CAFO FACILITY INSPECTION REPORT

<u>8365940001</u> WDID NUMBER	<u>Rodger Camping</u> OWNER NAME	<u>Eagle Livestock</u> FACILITY NAME
<u>CAG018001</u> NPDES NUMBER	<u>Ex. 6 Personal Privacy (PP)</u> OWNER ADDRESS	<u>Ex. 6 Personal Privacy (PP)</u> FACILITY ADDRESS
<u>R8-2007-0001</u> RWQCB ORDER NO.	<u>Chino, CA 91710</u> OWNER CITY AND STATE	<u>Ontario, CA 91762</u> FACILITY CITY AND STATE
<u>03/05/2013</u> SCHEDULED INSPECTION DATE	<u>Rodger Camping</u> OWNER CONTACT	<u>Kyle Fulmer</u> FACILITY CONTACT
<u>03/05/2013</u> ACTUAL INSPECTION DATE	<u>Ex. 6 Personal Privacy (PP)</u> OWNER PHONE NO.	<u>Ex. 6 Personal Privacy (PP)</u> FACILITY PHONE NO.
<u>Unknown</u> RECEIVING WATER	<u>Ex. 6 Personal Privacy (PP)</u>

REPORT PREPARED BY: Anthony D'Angelo (PG Environmental, LLC) ON 03/13/2013

Photograph 2. View facing northeast of the existing east process wastewater pond located in the southeast corner of the Facility. Note process wastewater was observed actively flowing into the northwest corner of the pond. Also note the pond did not contain a depth marker.

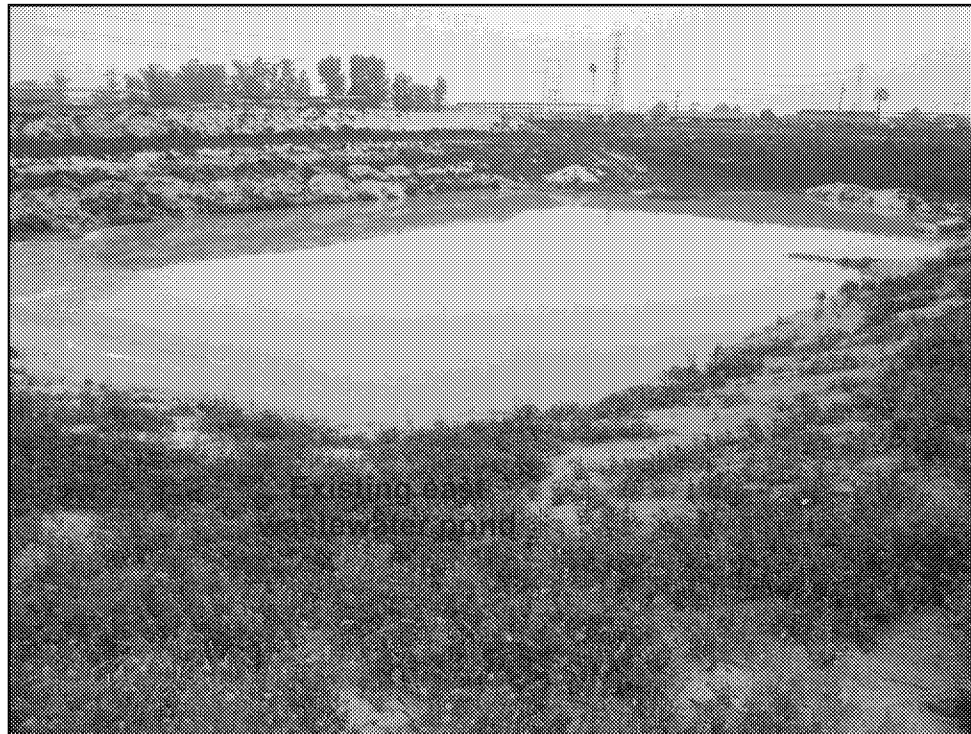
1. Depth markers were not installed in the existing east process wastewater pond, or in the other six (6) catch basins identified onsite during the inspection, as required by Permit Attachment B - Monitoring and Reporting Program, Section I.B.1 (refer to Photos 2, 3, and 4). This is a recurring issue identified in a previous inspection conducted on December 22, 2010.

Photograph 16. View facing southeast of the existing west process wastewater pond located in the southern portion of the Facility. Note vegetation growth was observed inside the pond and unconsolidated soils were observed on the embankment slopes of the pond. This pond did contain a depth marker.

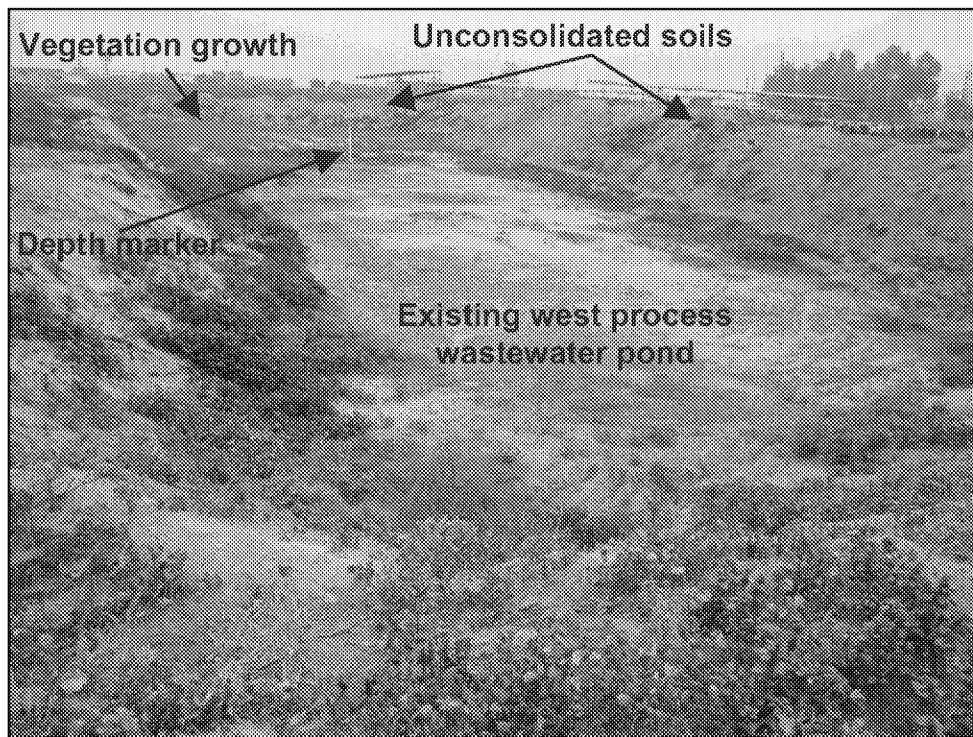
3. The inspectors observed, during the inspection, vegetation growth potentially affecting the containment structure capacity in the existing west process wastewater pond (refer to Photos 16 and 17). The 'Operation and Maintenance' section of the EWMP states that "excessive vegetation growth around containment structures will be controlled with mowing." Weed abatement is performed by Mr. Fulmer periodically; however, vegetation growth was observed inside the pond at the time of the inspection. As a result, the overall capacity of the existing west process wastewater pond at the Facility may be diminished. Provision VII.C.3.a of the Permit states that "the discharger shall design, construct, and maintain containment structures to retain all wastewater within the facility, including all process wastewater and all precipitation on, and drainage through, manured areas resulting

from rainfall up to and including a 25-year, 24-hour rainfall event." The Discharger must design and maintain all containment structures per the EWMP as required by Provisions VII.C.3.a-b of the Permit.

Photograph 18. View facing northeast of unconsolidated soil stockpiles located on the southern and eastern embankment slopes of the existing west process wastewater pond. Note a soil stockpile was obstructing the emergency spillway located on the south side of the pond.

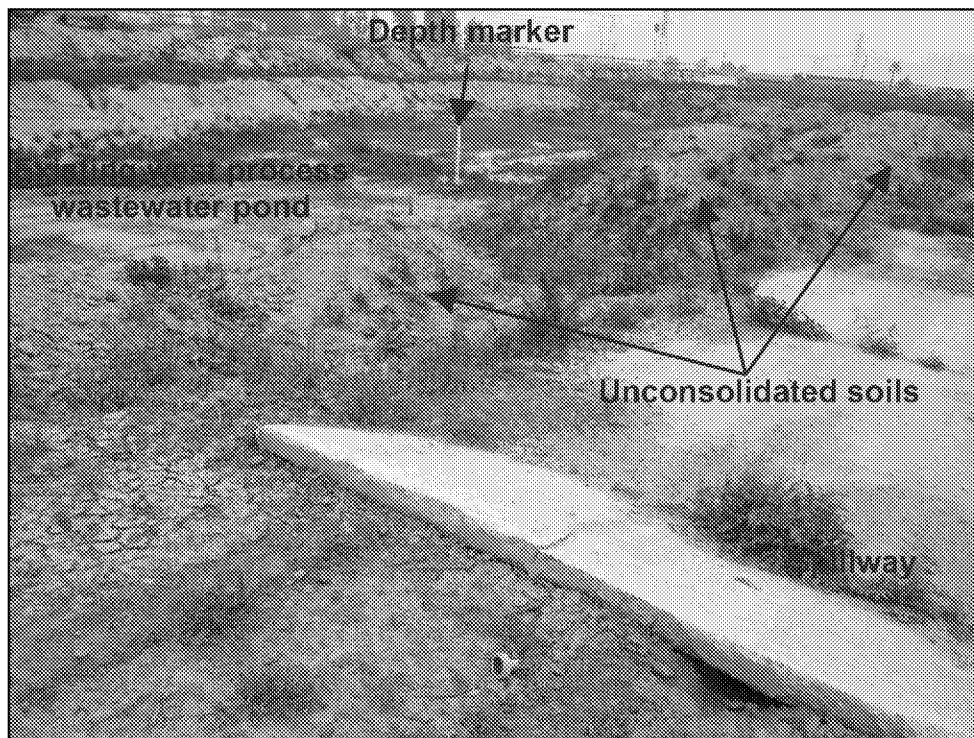
5. The inspectors observed, during the inspection, unconsolidated soil stockpiles along the southern and eastern embankment slopes of the existing west process wastewater pond (refer to Photos 16 and 18). The overflow spillway on the south central side of the existing west process wastewater pond was observed obstructed by multiple unconsolidated soil stockpiles (refer to Photo 18). The 'Proposed Waste Management Plan' section of the EWMP states that "an emergency spillway has been added along the west berm to allow a 100-year, 24-hour storm (52.2 CFS) to flow through at a velocity less than 5.0 feet per second. At this velocity, erosion will not be a concern." As a result of the unconsolidated soil stockpiles location, flow discharging out of the existing west process wastewater pond emergency spillway would be obstructed. In addition, the EWMP states that the emergency spillway is present on the west berm; however, the inspectors observed the spillway had been constructed on the south berm (refer to Photo 18). Provision VII.C.3.a of the Permit states that "the discharger shall design, construct, and maintain containment structures to retain all wastewater within the facility, including all process wastewater and all precipitation on, and drainage through, manured areas resulting from rainfall up to and including a 25-year, 24-hour rainfall event." The Discharger must design and maintain all containment structures per the EWMP as required by Provision VII.C.3.a of the Permit.

Photograph 19. View facing west of a gap in the eastern containment berm of the southeast catch basin, shown in Photograph 3.

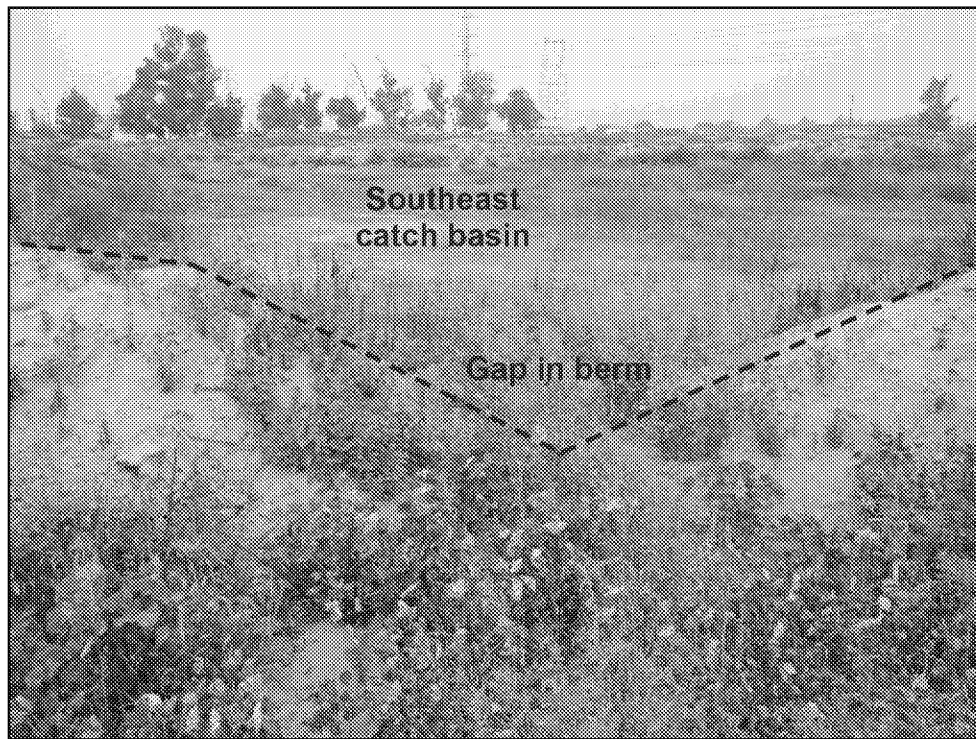
6. The inspectors observed, during the inspection, a gap in the containment berm on the east side of the southeastern catch basin (refer to Photo 19). An overflow out of the basin through the gap has the potential to discharge offsite and onto the adjacent dairy, Basque-American No. 1. It should be noted that this catch basin is not identified in the Facility's approved EWMP. Effluent Limitations and Discharge Specifications V.A.1.a specifies that production areas (e.g., waste confinement areas) must be designed to maintain all process water including the runoff and the direct precipitation from a 25-year, 24-hour rainfall event. It should be noted that an issue with Facility containment structure berm maintenance was noted during a previous inspection conducted on December 22, 2012. Provision VII.C.3.a of the Permit states that "the discharger shall design, construct, and maintain containment structures to retain all wastewater within the facility, including all process wastewater and all precipitation on, and drainage through, manured areas resulting from rainfall up to and including a 25-year, 24-hour rainfall event." The Discharger must design and maintain all containment structures per the EWMP as required by Provision VII.C.3.a of the Permit.
